Tamishna Fashion Wear Ltd. (Unit-2) (10325)

Identified Priority 1 Concerns

2nd Priority 1 Concern

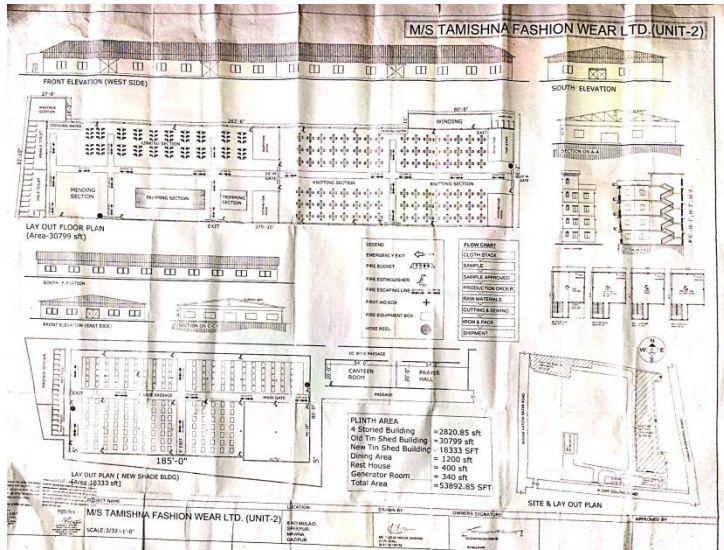
The connections of truss members with the circular column were very poor. Again the positioning of columns with respect to truss members is irregular.

6	2nd Priority 1 - The connections of truss member and the positioning of columns with truss members are irregular in the new shed.	If deemed necessary by the Factory Engineer, carry out any remedial works recommended.	6-months
7	1st Priority 3 - No structural drawings for any building and sheds	Begin a structural survey for all the buildings and sheds.	6-weeks
8	1st Priority 3 - No structural drawings for any building and sheds	Produce as built structural drawings that depict the actual site conditions.	6-months
